CITY OF ALBUQUERQUE

**Re: Starbuck's
4301 San Mateo Blvd.NE
Request Temporary C.O. - Accepted
Engineer's Stamp dated: 2-9-15 (G17D006C)
Certification dated: 10-7-15**

SHEET TITLE:
GRADING & DRAINAGE PLAN
AS-BUILT

C301

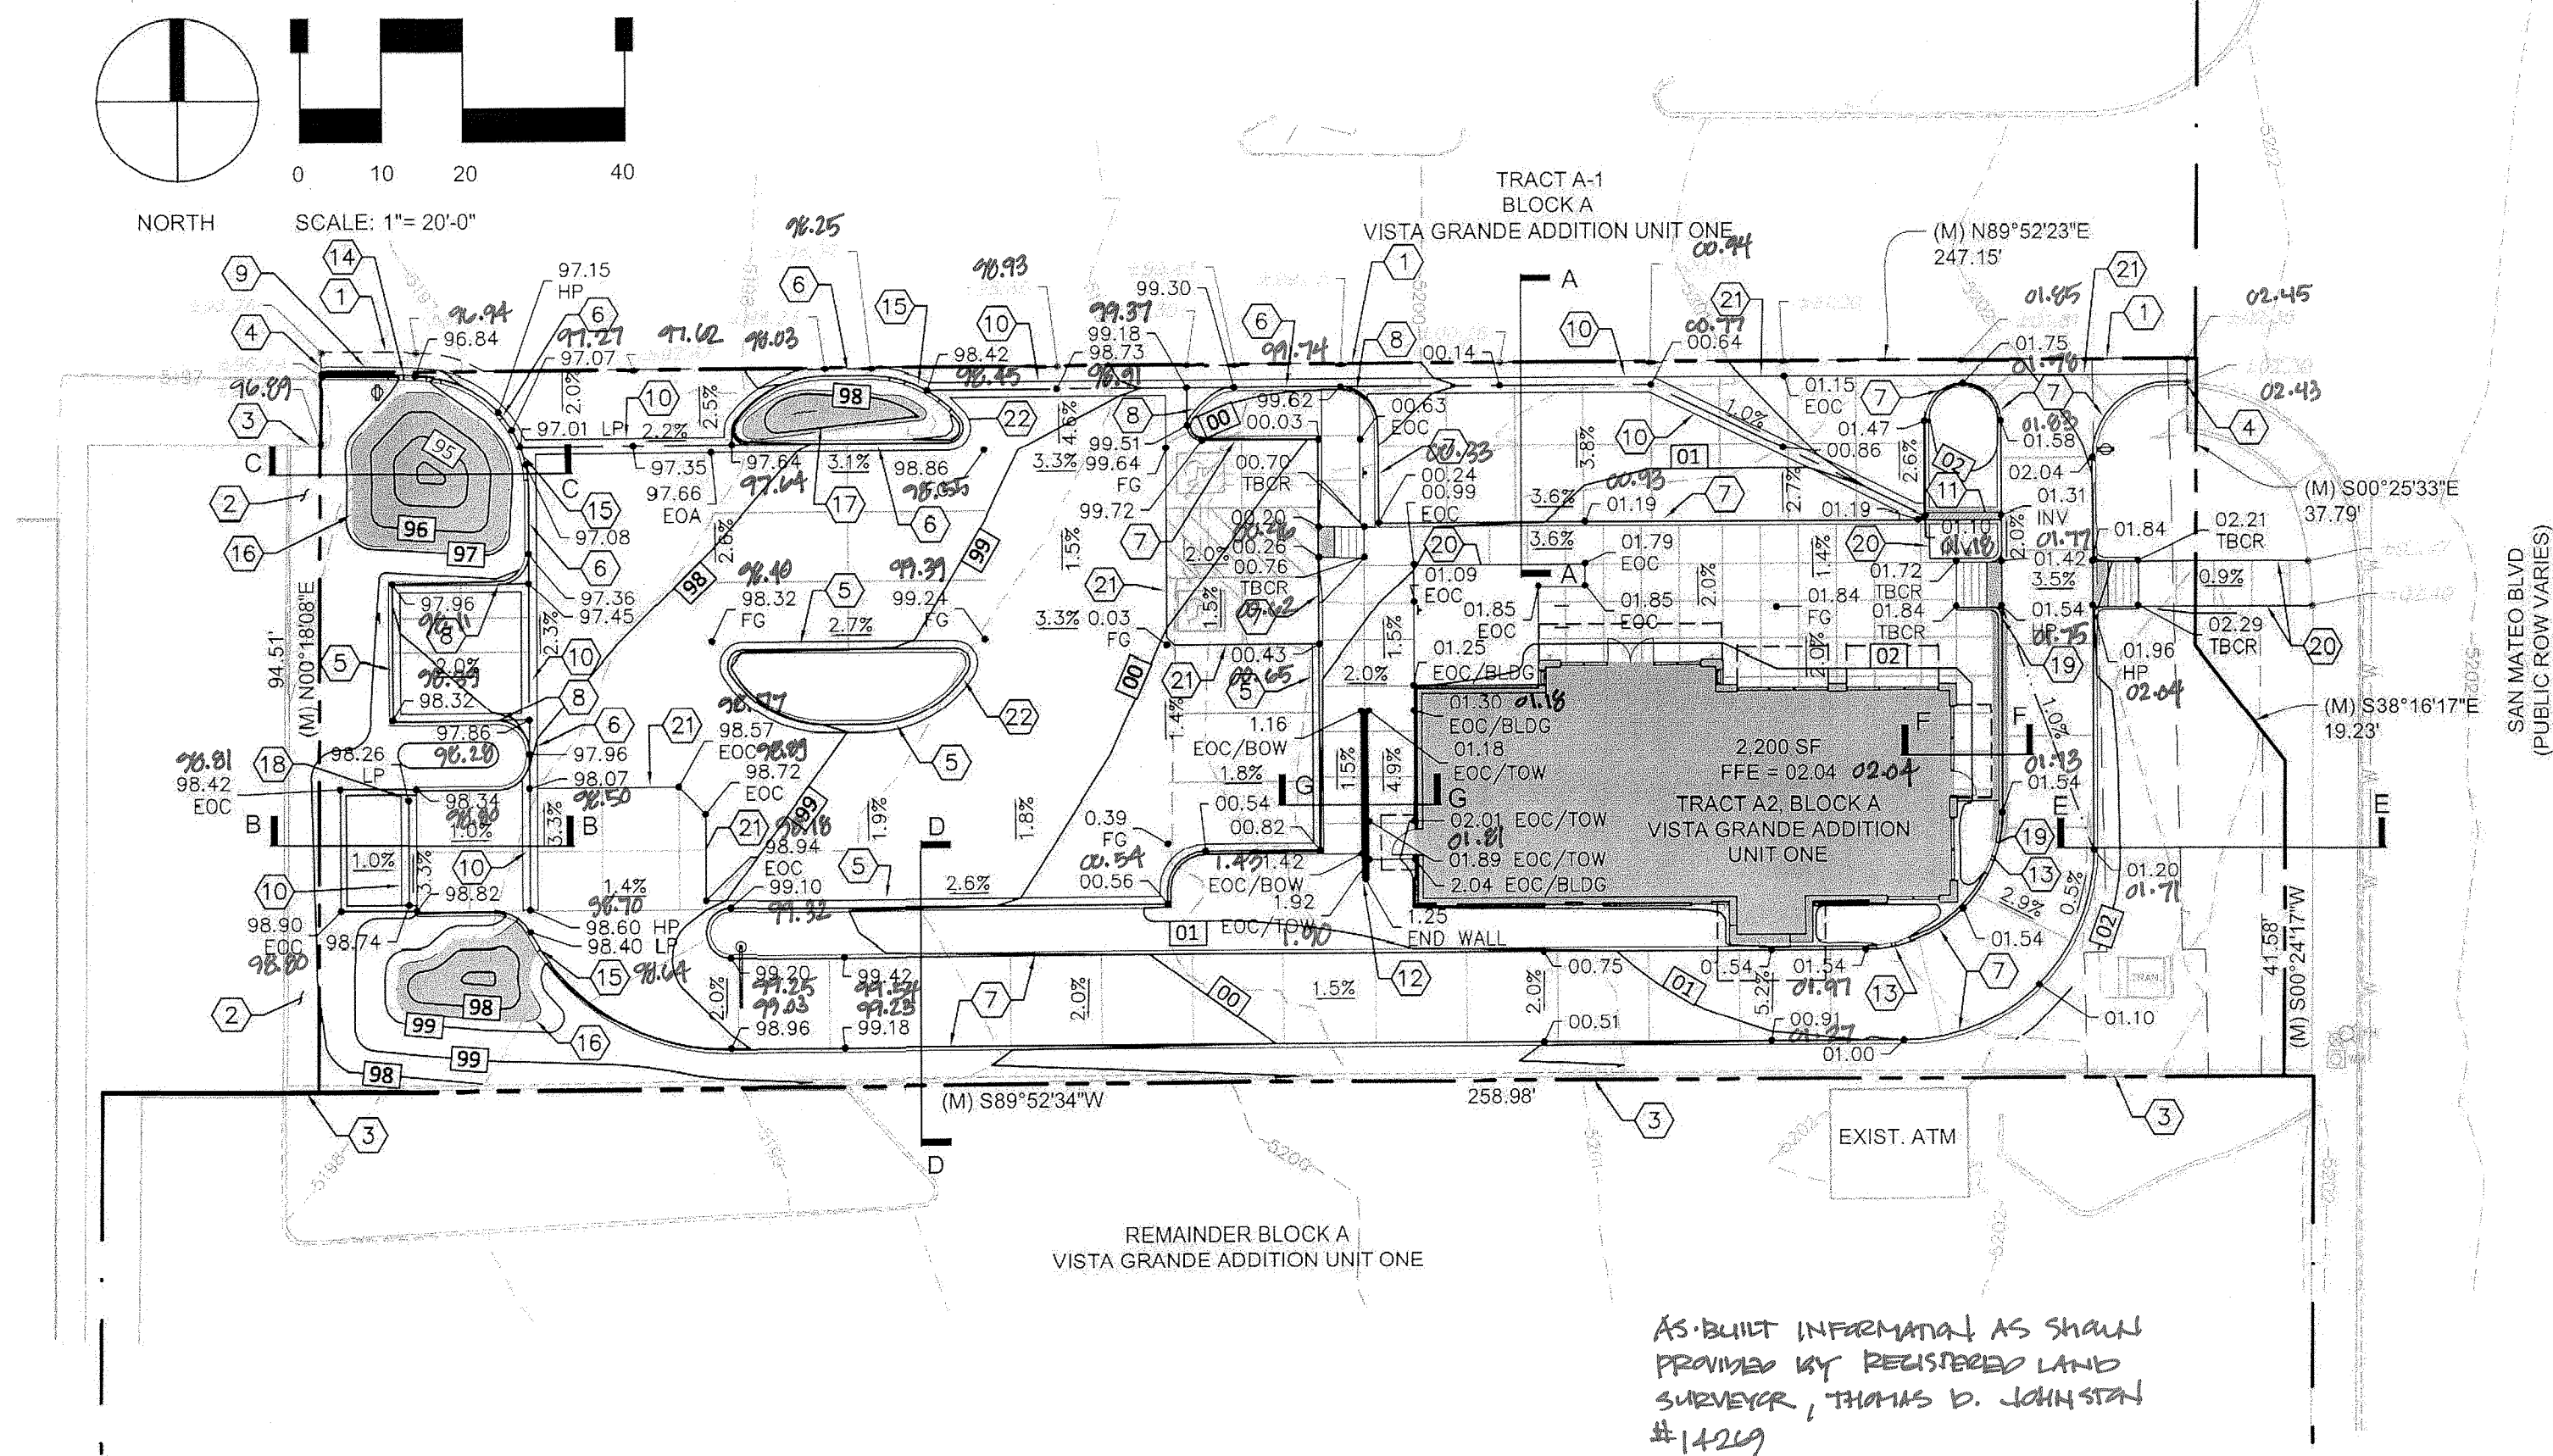
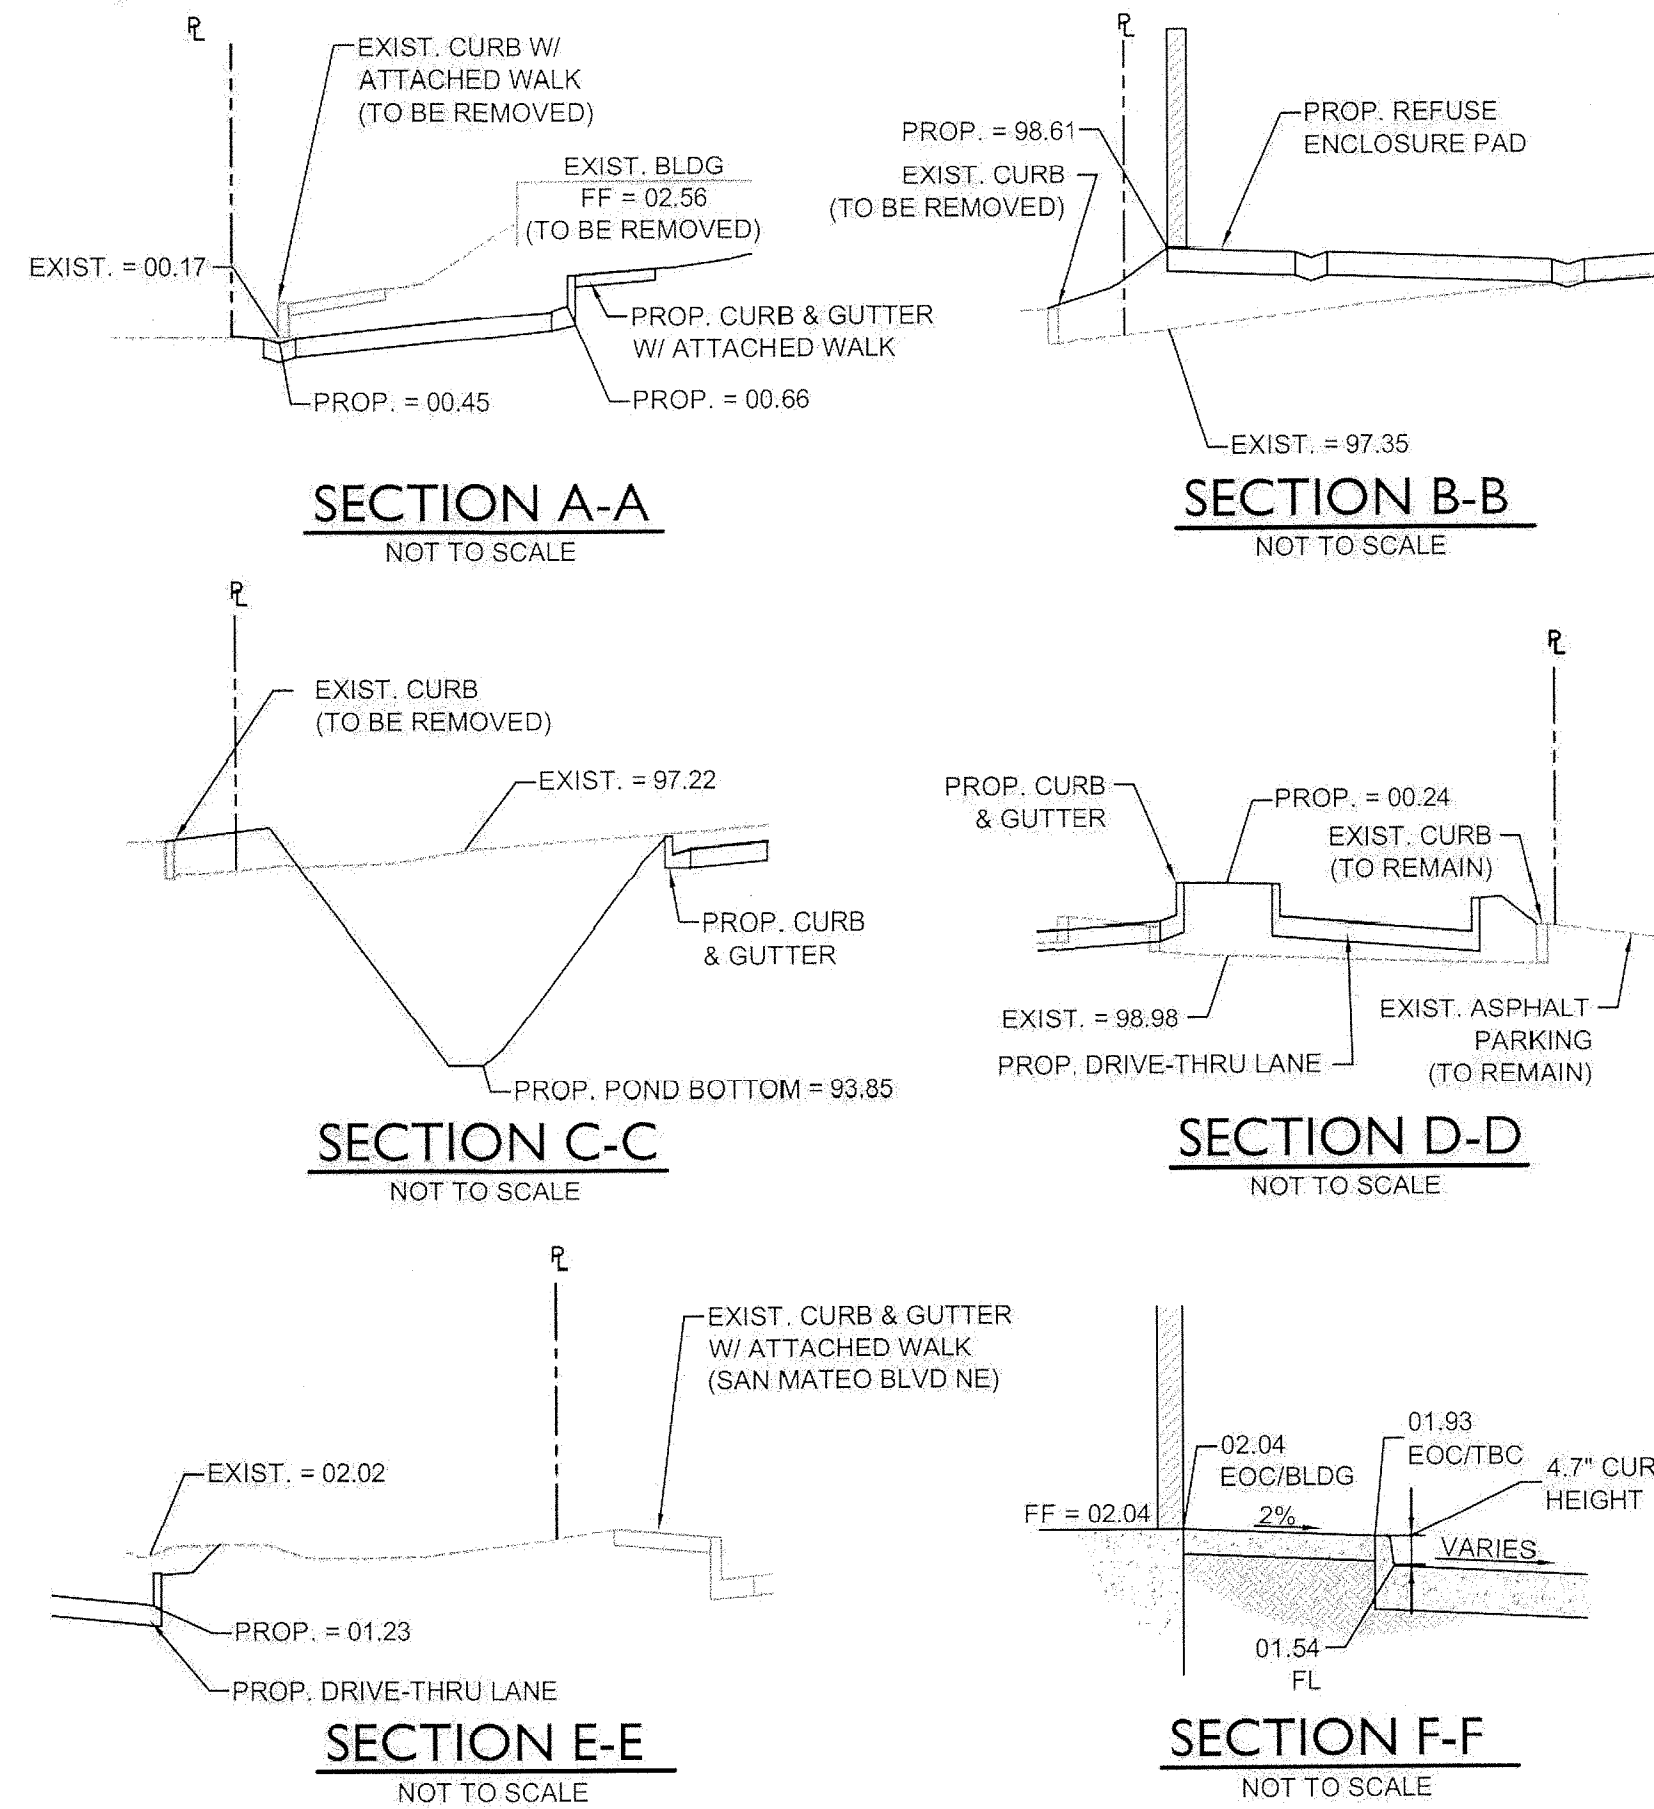
Upon review it has been found that the ponds and depressed landscape island are not complete. Concrete pan(s) are noted on the as-built as not constructed. Other deviations from the grading and drainage design described on the approved plan(s) represent discrepancies which are minor in nature and/or should impact maintenance of the property rather than the overall drainage design intent.

Based on the review described herein, of the information listed herein, and of this information only, it appears the completed improvements as described herein, associated with the grading and drainage aspects of the project have been graded and will drain in substantial compliance with the overall design intent of the approved plan(s). Once the ponds are complete, a revised letter of conformance will be submitted in support of a request for a permanent Certificate of Occupancy.

Based on the Certification received 10/7/2015, the site is acceptable for temporary release of Certificate of Occupancy by Hydrology.
